Final Environmental Impact Report

Michelson Water Reclamation Plant Phase 2 and 3 Capacity Expansion Project

State Clearinghouse No. 2005051174

FEBRUARY 2006

Figure 1 Existing Land Surface Conditions

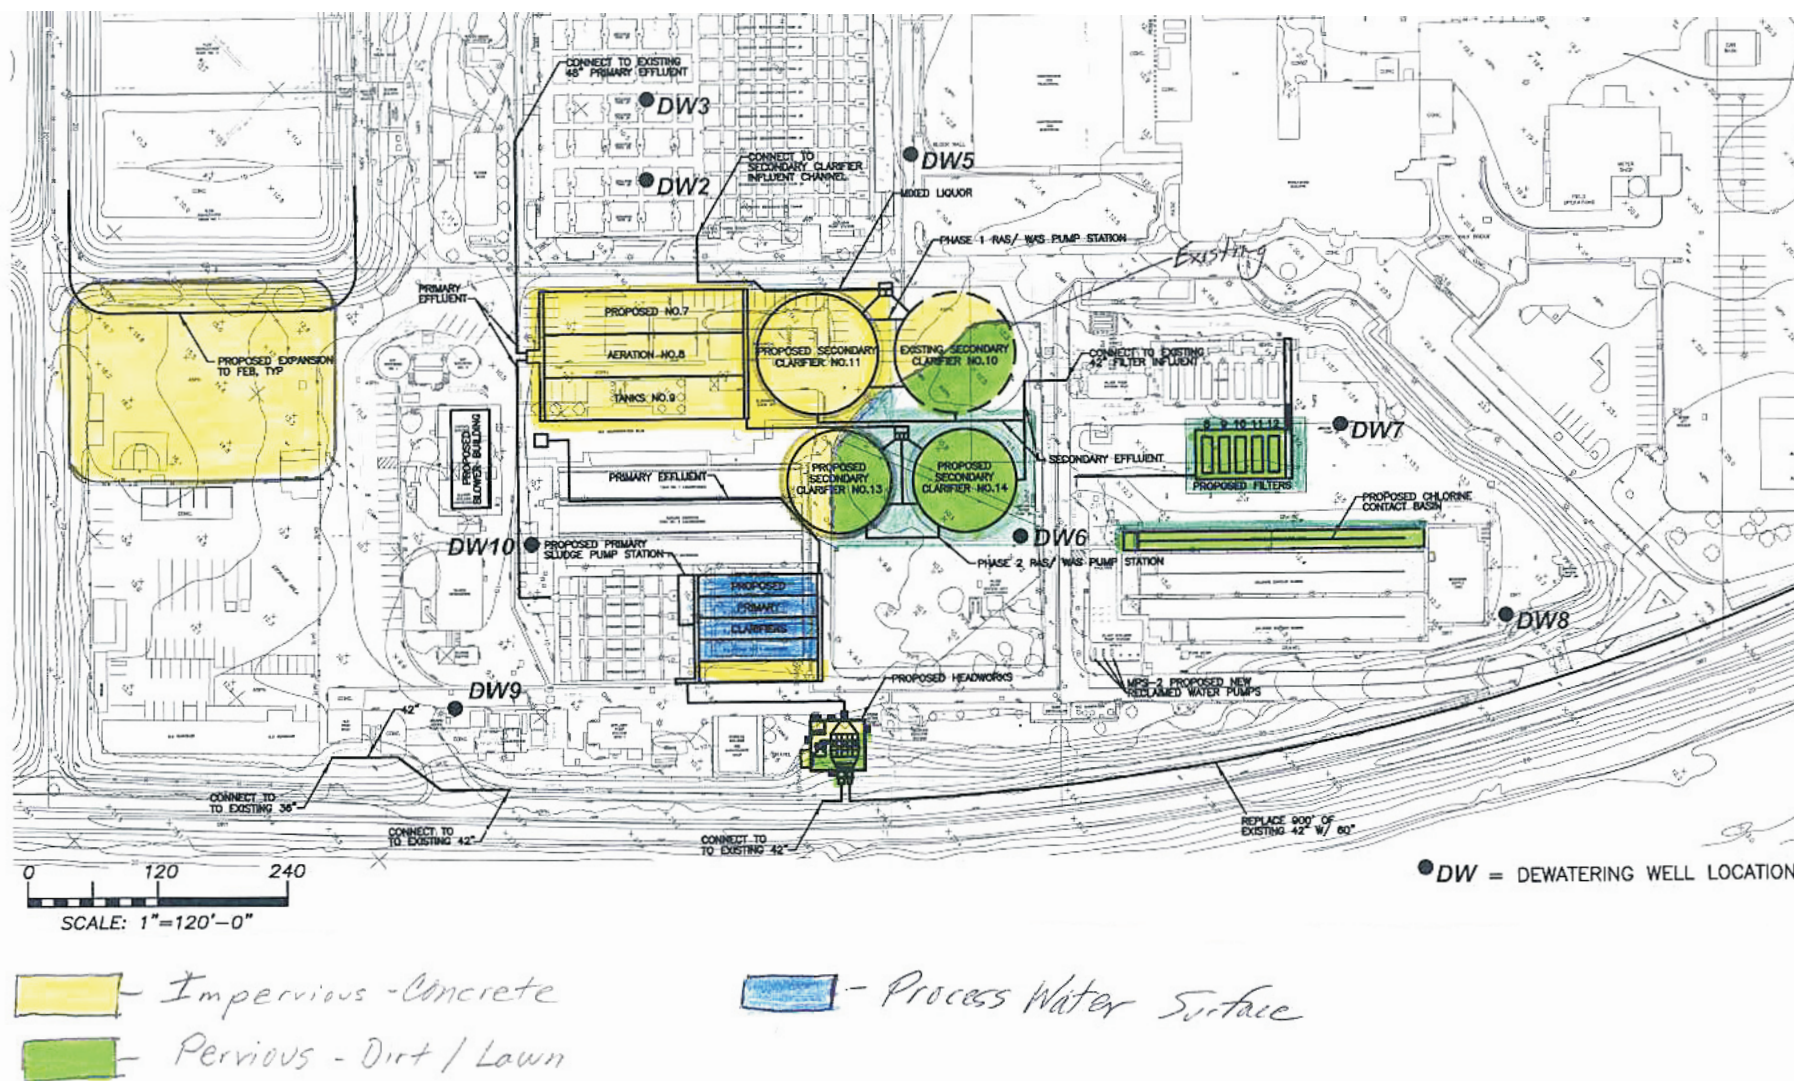
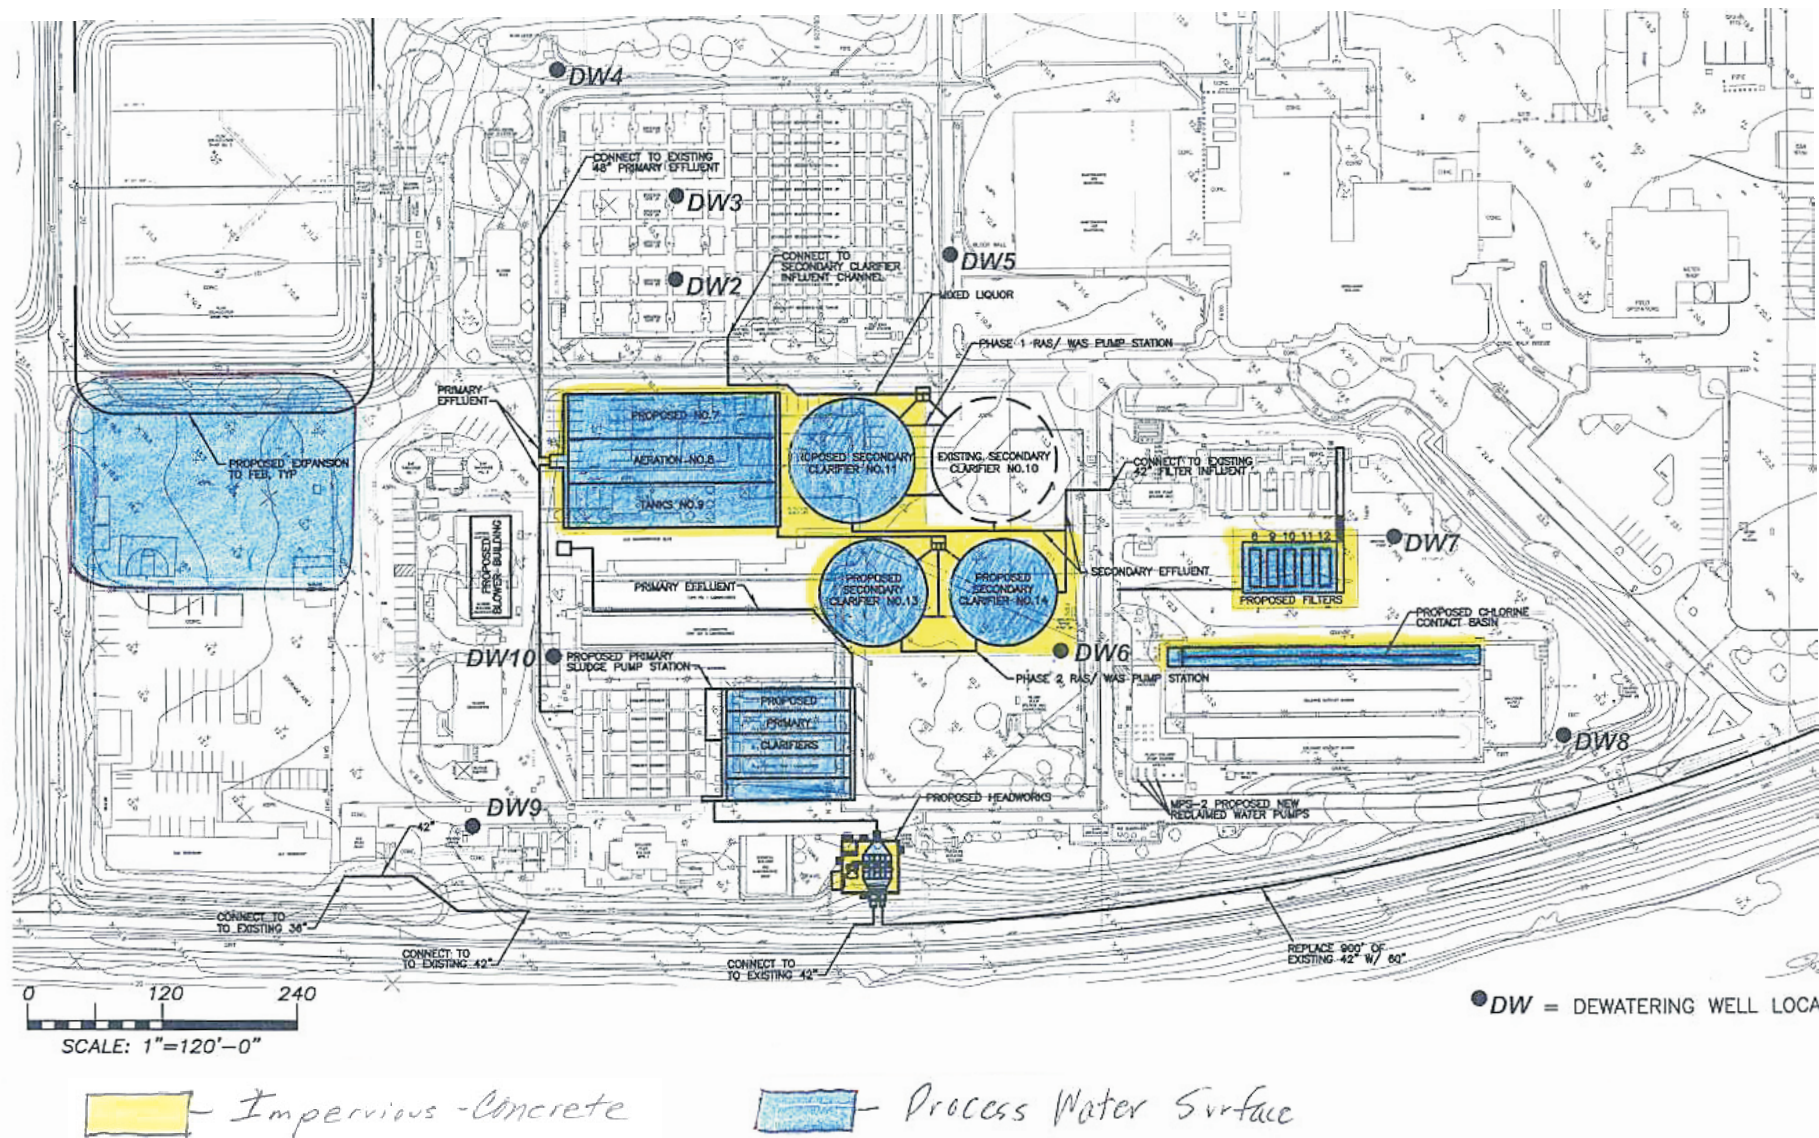
"Impact H-8" (page 4.2-37): The DEIR asserts, without proof, that the increased storm runoff due to added impervious surfaces will be more than offset by the fact that such runoff water will be pumped to the plant headworks and treated as part of the reclamation process. This assertion needs clarification. What is the additional runoff volume due to the facility expansion for a 25-year frequency, 24-hour duration storm? Will there be additional flooding over the settlement basins that could carry polluted water to the San Diego Creek and Upper Newport Bay?

A5-7 The Draft EIR states that the pump stations, which collect and pump storm runoff to the plant headworks for treatment, are sized for the 25 year storm. The report also states that the SWPPP will be revised as the expansion of the MWRP will add new impermeable surfaces and runoff may increase. The DEIR calculated an increase in runoff just using surface categories of industrial areas, concrete/asphalt and lawn.

Calculations done in response to this comment indicate that while some areas that currently consist of lawn or dirt will be replaced with concrete, larger areas that are currently concrete will be replaced with open-top tanks or open water surface features. The following Figures 1 and 2 show the areas that currently are and will be, under the proposed project, lawn/dirt, concrete/asphalt, or open water surface.

As shown on the following Table 1, the current distribution of lawn/dirt, concrete/asphalt, and water surface areas as shown on Figure 1 is 0.7 acre, 1.7 acres, and 0.2 acre, respectively. Under the proposed project, the distribution of lawn/dirt, concrete/asphalt, and water surface areas as shown on Figure 2 is 0 acre, 2.2 acres, and 2.6 acres, respectively. Therefore, although new impermeable surfaces will be added and the area of concrete/asphalt will increase with respect to lawn/dirt areas, the area of open water surfaces will increase substantially compared to the increase in concrete/asphalt areas. These open water surfaces will not contribute runoff water. Therefore, the area contributing to storm water runoff will decrease by approximately two acres as a result of the proposed project.
